Markets Committee

Committee(s):	Date(s):
Markets Committee	30 November 2016
Streets & Walkways Sub-Committee For Decision	6 December 2016
Subject: North – South Cycle Superhighway Phase 2: The City’s response	Public
Report of: Director of the Built Environment	For Information
Report Author: Sam Lee	
<p style="text-align: center;">Summary</p> <p>TfL, on behalf of the Mayor of London, carried out a public consultation exercise on proposals to extend their North – South Cycle Superhighway to Kings Cross in early 2016. A number of major concerns were expressed by the City. However, since then, TfL has worked with City officers to improve the proposals. The current layout, which is under further consultation, addresses most of the City’s concerns but a few minor issues remain.</p> <p>Officers consider that the revised proposals offer substantial safety benefits, good and safer cycling route connectivity between the Cycle Quietways and the Cycle Superhighway and provide for the much needed pedestrian crossing facilities at the Farringdon Street/West Smithfield and the Farringdon Road/Charterhouse Street junctions. However, the SMTA and the Markets and Consumer Protection Department have

Appendix 9 (2 of 2) - Banned Left Turn : Alternative Routes

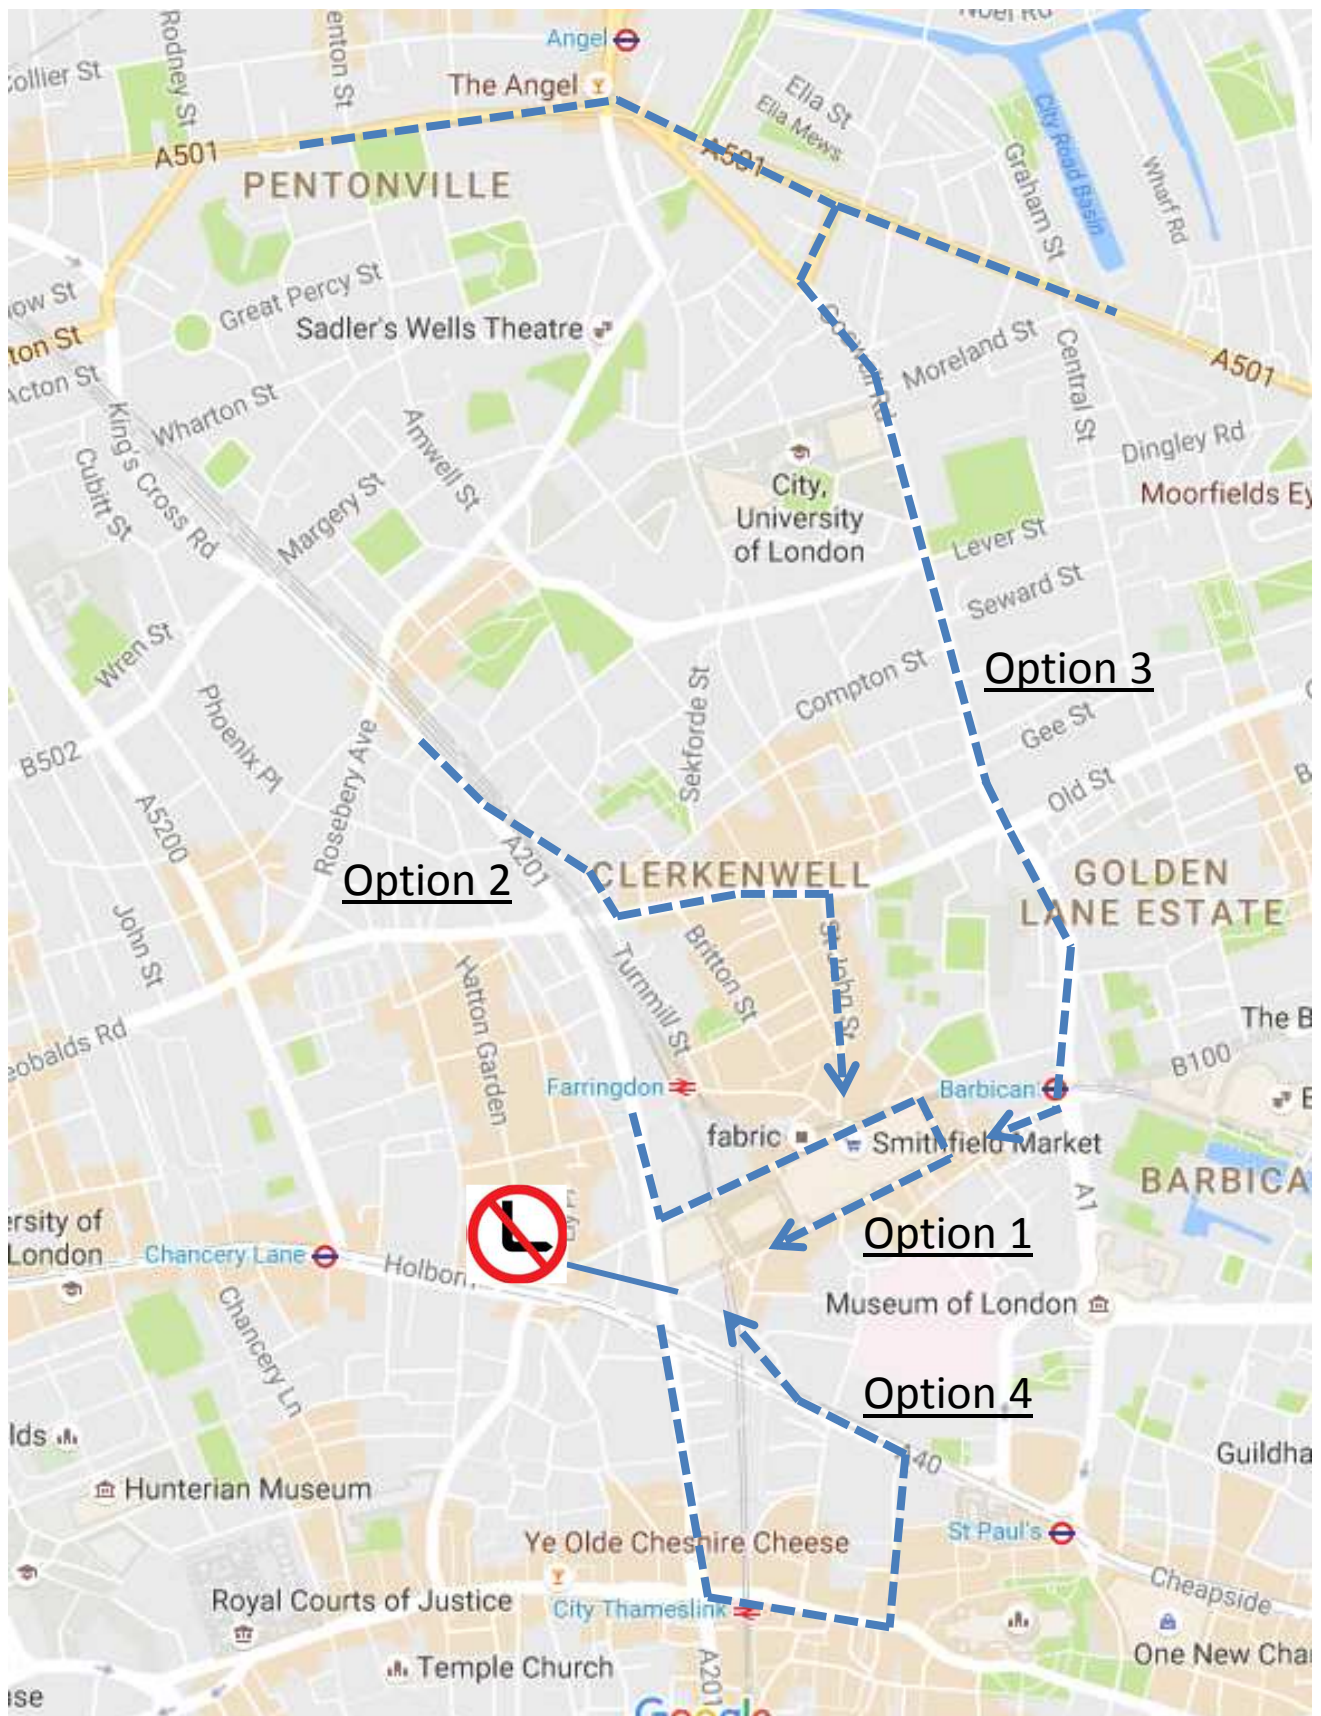
- 14. The SMTA and the Markets and Consumer Protection Department have both expressed concern with the banned left turn, as this would send more traffic to travel around the market. Their concerns are that this would add further congestion to an already congested network, safety implications and would result in a much longer diversion for some traders. An ability to enable the left turn during peak market activities (e.g. between 9pm – 5am) has been suggested but currently not supported by TfL because they consider this will introduce additional road danger.

- 16. The nearest and simplest diversionary routes for both banned turns would be to turn left into Charterhouse Street (east) and to proceed around the market. Alternatively, traffic can continue down Farringdon Street and then turn left or right at Ludgate Circus and then use other City streets to reach their destination. There are also other good diversionary routes available further north, such as using Rosebury Avenue, the Inner Ring Road, and other streets. These routes would be more appropriate for some of the diverted traffic. Appendix 9 provides a map of the diversionary routes.
